Contract #: 04-0120F4Cty: SF/ALA Rte: 80 PM: 13.2/13.9File #: 69.25B**QUALITY ASSURANCE -- NON-CONFORMANCE REPORT****Location:** Changxing Island, Shanghai, P.R. China**Report No:** NCR-000764**Prime Contractor:** American Bridge/Fluor Enterprises, a JV**Date:** 13-Jun-2010**Submitting Contractor:** Zhenhua Port Machinery Company, Ltd (ZPMC), Changxing Island**NCR #:** ZPMC-0726**Type of problem:**

Bridge No: 34-0006**Component:** OBG Segment 7BW FL3 Bottom Panel Stiffeners

Reference Description: ZPMC performed welding without conforming to the approved WPS and ZPMC's Welding Repair Report

Job Name: SAS Superstructure

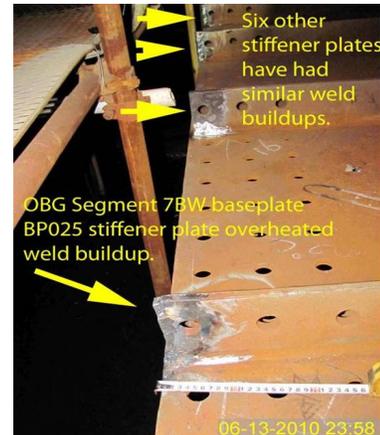
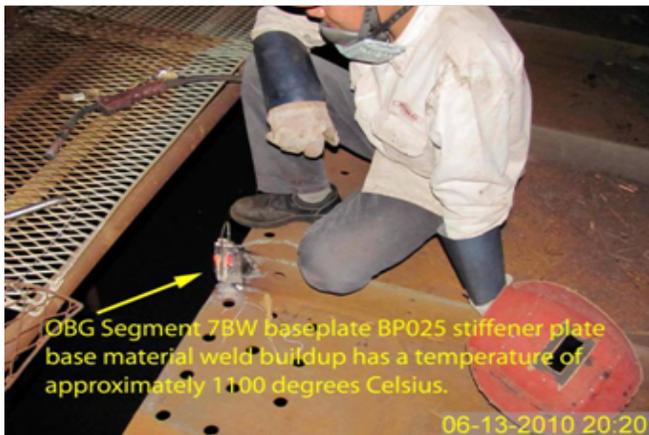
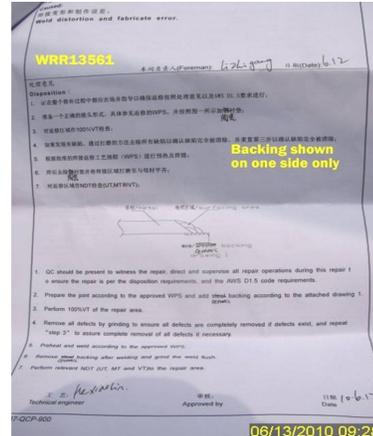
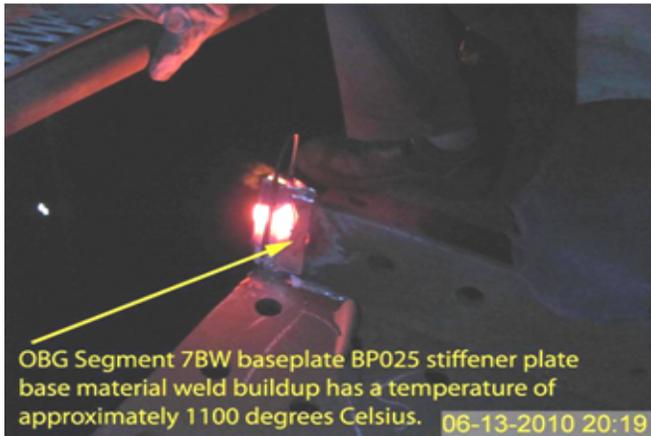
-ZPMC personnel performed weld buildup (buttering) on the ends of the bottom panel stiffeners using weld repair document B-WR13561.

-The welder used two ceramic backing bars, one on each side of the stiffener.

-Multiple weld passes were deposited in the vertical position.

-This QA measured the interpass temperature and observed the weld and adjacent base metal melted an 1100°C Temp stick. Maximum interpass temperature allowed is 230°C.

-This QA noted that the bottom panel and fillet welds joining the stiffeners to the bottom panel are designated on the approved shop drawings as Seismic Performance Critical Material (SPCM).

The additional weld metal added needs to be replaced as the material was superheated and ceramic backing was used to perform buttering.

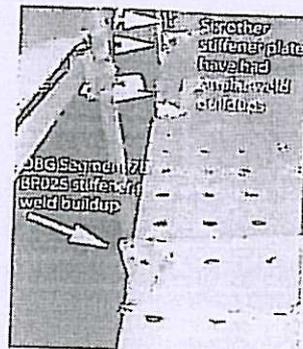
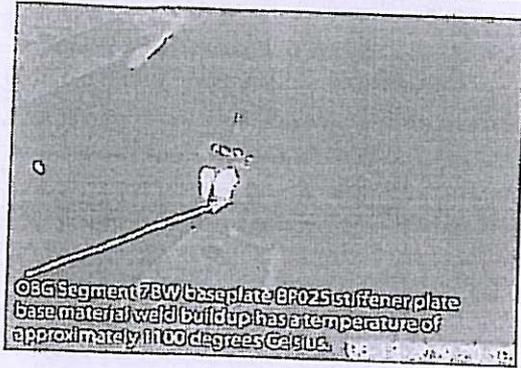
-ZPMC personnel performed weld buildup (buttering) on the ends of the bottom panel stiffeners using weld repair document B-WR13561.

-The welder used two ceramic backing bars, one on each side of the stiffener.

-Multiple weld passes were deposited in the vertical position.

-This QA measured the interpass temperature and observed the weld and adjacent base metal melted at 1100°C Temp stick. Maximum interpass temperature allowed is 230°C.

-This QA noted that the bottom panel and fillet welds joining the stiffeners to the bottom panel are designated on the approved shop drawings as Seismic Performance Critical Material (SPCM).

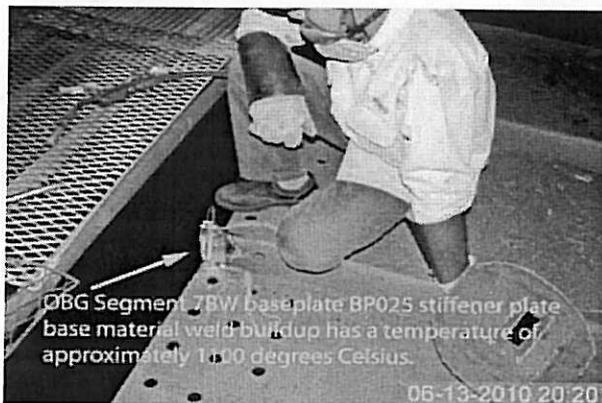
-ZPMC personnel performed weld buildup (buttering) on the ends of the bottom panel stiffeners using weld repair document B-WR13561.

-The welder used two ceramic backing bars, one on each side of the stiffener.

-Multiple weld passes were deposited in the vertical position.

-This QA measured the interpass temperature and observed the weld and adjacent base metal melted an 1100°C Temp stick. Maximum interpass temperature allowed is 230°C.

-This QA noted that the bottom panel and fillet welds joining the stiffeners to the bottom panel are designated on the approved shop drawings as Seismic Performance Critical Material (SPCM).

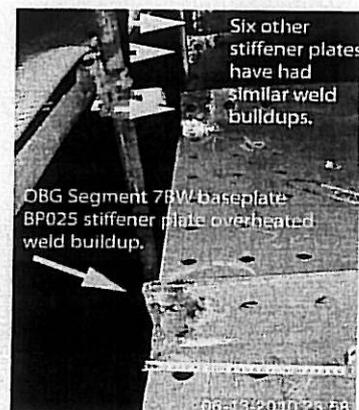
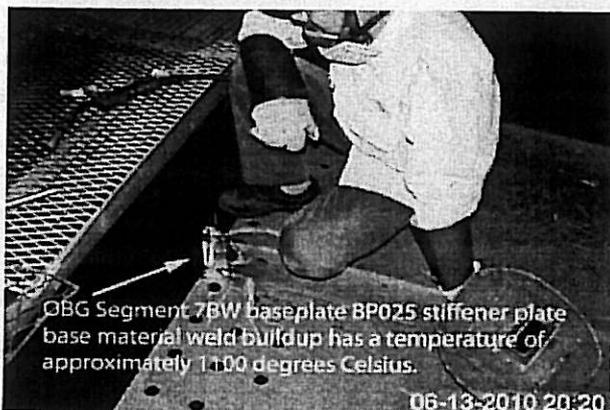
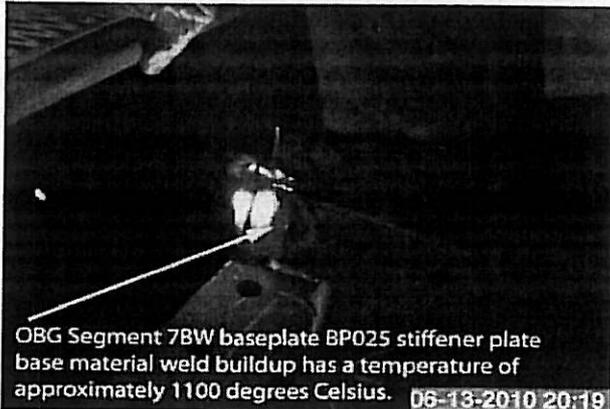
-ZPMC personnel performed weld buildup (buttering) on the ends of the bottom panel stiffeners using weld repair document B-WR13561.

-The welder used two ceramic backing bars, one on each side of the stiffener.

-Multiple weld passes were deposited in the vertical position.

-This QA measured the interpass temperature and observed the weld and adjacent base metal melted an 1100°C Temp stick. Maximum interpass temperature allowed is 230°C.

-This QA noted that the bottom panel and fillet welds joining the stiffeners to the bottom panel are designated on the approved shop drawings as Seismic Performance Critical Material (SPCM).

Remove weld metal and replace in accordance with the approved welding repair procedure.
